# Review of Environmental Factors Addendum

Wilton Growth Area – relocation of SP1234

Figure 1 Proposed location of SP1234

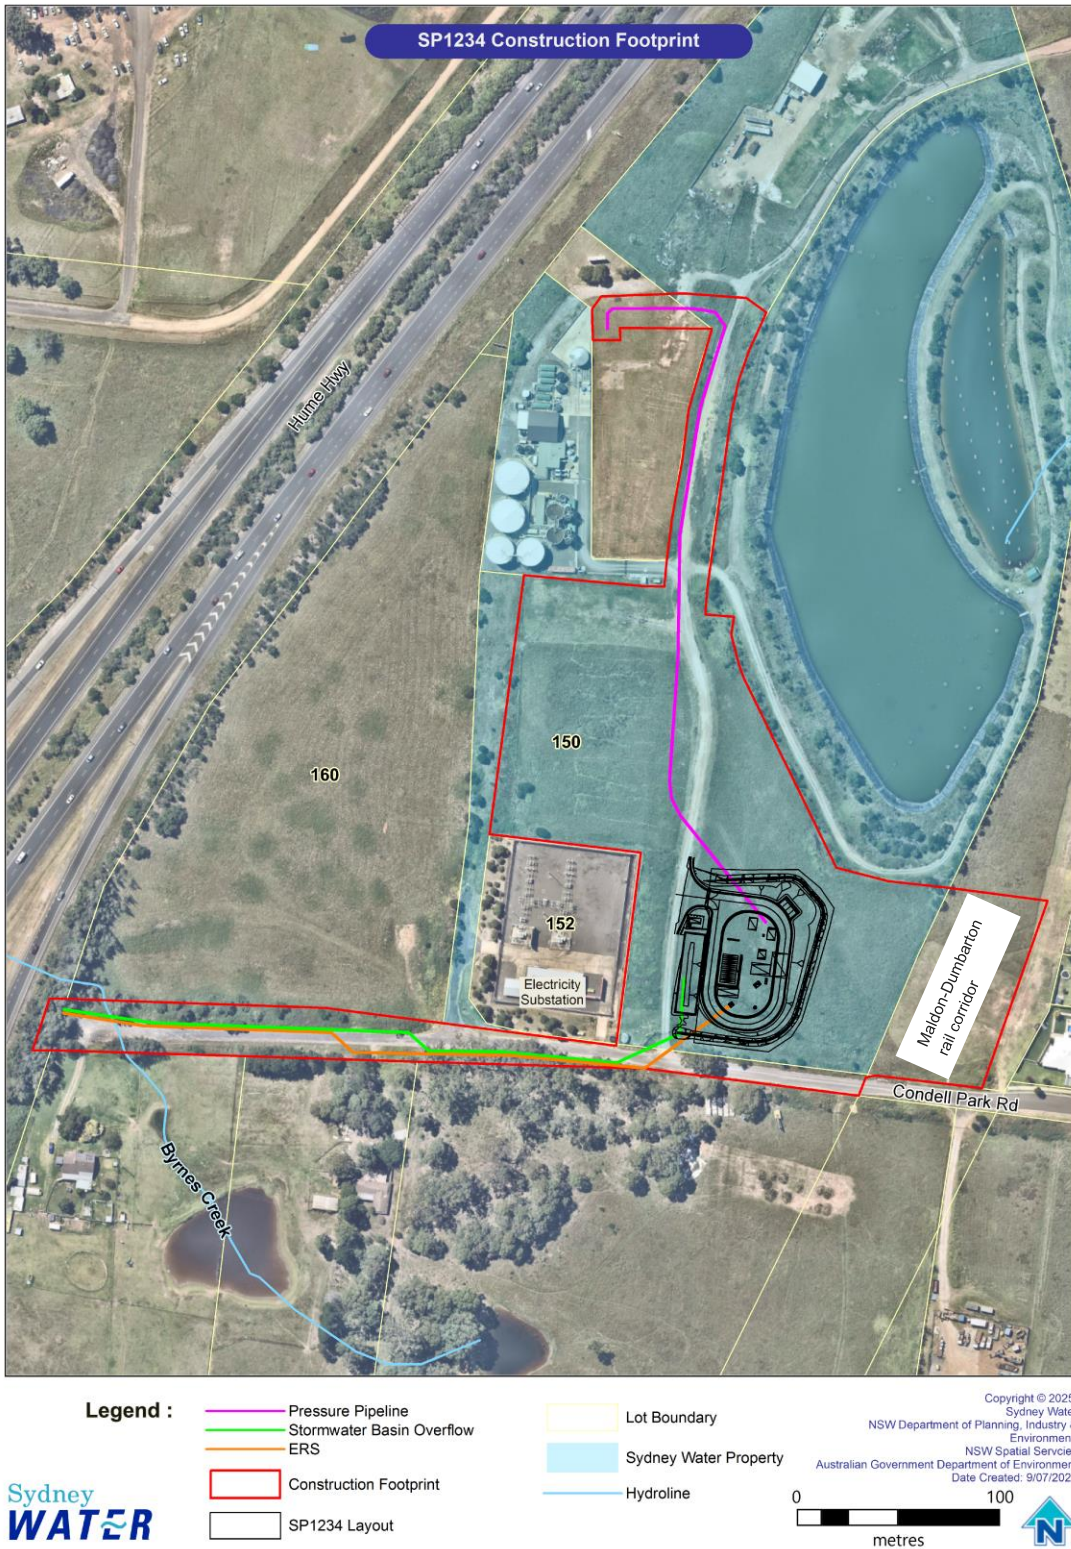
Aspect	Detailed description
<b>Proposal location</b>	<p>The proposal is located in the town of Wilton within the Wollondilly Shire local government area (LGA). The proposal is located on Sydney Water land, rail corridor and in road reserves:</p> <ul style="list-style-type: none"><li>• 150 Condell Park Road (Sydney Water land). This is the site of the Wilton Water Resource Recovery Facility (Wilton WRRF)</li><li>• Part of the Maldon Dombarton rail corridor. There is no rail infrastructure at this location. Work in the corridor will be temporary construction work only</li><li>• Condell Park Road reserve</li><li>• Hume Motorway reserve.</li></ul> <p>Figure 1 shows the location of the proposal.</p>
<b>Approved REF</b>	<p>Wilton Growth Area - Wastewater Infrastructure Review of Environmental Factors (May 2024).</p>
<b>Proposal scope</b>	<p>The approved REF assesses construction and operation of new wastewater infrastructure servicing the initial stages of residential development in South East Wilton and North Wilton, and existing residents in Bingara Gorge. The main components of the proposal are:</p> <ul style="list-style-type: none"><li>• two wastewater pumping stations (SP1233 and SP1234)</li><li>• gravity pipeline connected to each new pumping station</li><li>• pressure pipeline from each pumping station to Wilton WRRF.</li></ul> <p>SP1234 will be located on Condell Park Road, near the Wilton WRRF. The gravity pipeline to SP1234 will be constructed using micro-tunnelling and the pressure pipeline from SP1234 constructed using open trenching.</p> <p>Infrastructure at SP1234 will be mostly underground. Above ground infrastructure includes a single-story building, kiosk and chemical dosing unit. An emergency relief structure (ERS) will be constructed from both pumping stations. The ERS from SP1234 will discharge to Byrnes Creek at a culvert under the Hume Motorway.</p> <p>Sydney Water proposes to change the location of SP1234 and alignment of associated gravity and pressure pipelines. SP1234 will be relocated about 130 m east of the approved location, from 160 Condell Park Road to 150 Condell Park Road.</p> <p>Figure 1 shows the realigned pressure pipeline. The proposed pressure pipeline will be constructed using open trenching. The change in alignment of the gravity pipeline involves redirecting a micro-tunnel from the approved location to the proposed location of SP1234. No additional ground disturbance will be required as the receival pit will be within the proposed construction footprint of SP1234.</p> <p>The ERS will be aligned along the southern side of Condell Park Road to avoid high voltage cables on the northern side of the road, at the electricity</p>

substation. The ERS will discharge to a culvert under the Hume Motorway and is consistent with the ERS discharge location in the approved REF.

The proposed location of SP1234 was a farm dam in the past and is now filled. This location collects stormwater from the surrounding area. Discharging uncontrolled stormwater flows from SP1234 would have potential to scour the roadside swale drains. A stormwater detention basin will be constructed at SP1234 and a stormwater discharge pipe will generally follow the ERS alignment and also discharge to the culvert at the Hume Motorway.

The original location of the pumping station would impact the viability of development at 160 Condell Park Road. TfNSW plan to upgrade the intersection of Picton Road and the Hume Motorway. The original location of SP1234 would be close to the intersection and impact the upgrade work. Sydney Water proposes to relocate SP1234 to Sydney Water land (150 Condell Park Road). This would be a positive outcome for the property owner of 160 Condell Park Road and would minimise the potential for Sydney Water work to impact the TfNSW intersection upgrade. In addition, Sydney Water would not need to acquire land to construct SP1234.
